**11th CSPCWG/1st NCWG Meeting
Rostock, Germany, 27-30 April 2015**

Paper for Consideration by CSPCWG/NCWG

Charting Maximum Authorized Draught in Lieu of Bathymetry

Submitted by:	CSPCWG Chair
Executive Summary:	This Paper summarises discussions between Italy, the CSPCWG Secretariat and the TSMADWG in regard to charting maximum authorized draught information and outlines a proposal from Italy and associated issues related to charting maximum authorized draught in lieu of physical bathymetry.
Related Documents:	<ol style="list-style-type: none"> 1. CSPCWG9-08.14A Maximum Draught Areas; 2. CSPCWG Letter 07/2013 Actions from 9th CSPCWG Meeting: Group 3'Hydrography'; 3. CSPCWG Letter 13/2013 Follow Up to Letter 07/2013; 4. CSPCWG10-08.02A_Minimum_Depth_and_Maximum_Authorized_Draught 5. CSPCWG Letter 09/2014 CSPCWG10 Actions 10-14 (Dredged areas and maximum authorized draught); 6. CSPCWG Letter 13/2014 CSPCWG10 Actions 10-14 (Dredged areas and maximum authorized draught) – follow-up to Letter 09/2014.
Related Projects:	INT1 and S-4 Maintenance

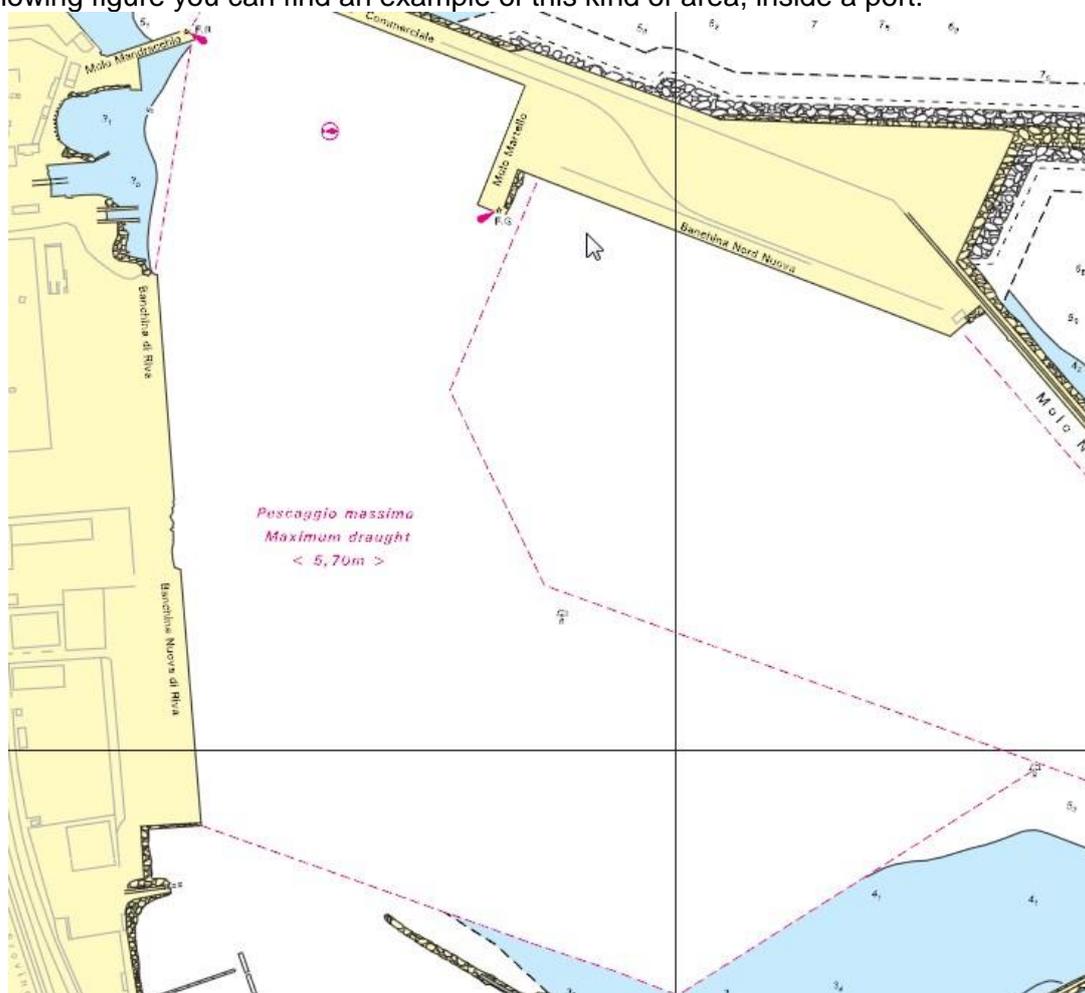
In the area shown in fig.1 we have multibeam hydrographic data acquired in 2012. The competent maritime authority, 2 years later, assured a maximum draught of 9,6 m. The same authority could not give the Italian HO any other official information about minimum depth.

Therefore, the inconsistency between maximum draught value and soundings is clearly represented in fig.1, where there is a sounding showing 11m (Chairman: I assume the better example soundings here are the depths that are shallower than 9.6m in the maximum authorized draught area) of depth inside the area where the maximum draught is 9,6m.

The Italian HO together with the local maritime authority has decided to represent only the maximum authorized draught using INT N1.2 magenta limit and the legend *Maximum draught <9.6m>*. As you can see in fig.2, soundings and depth contours are deleted, due the inconsistency with draught information.

- Is such portrayal a safe option? Noting the diagram included in the Italy response to CSPCWG Letter 09/2014 (see above) – in the example where the physical depth information has been omitted, there are physical depths that have been removed (soundings of value 9.2m and 9.4m) that are actually shoaler than the maximum authorized draught value (9.6m).

When it is possible, minimum depth and authorized maximum draught should both be quoted. In unusual cases, where the inconsistency between these data is manifest, only the maximum authorized draught may be represented.
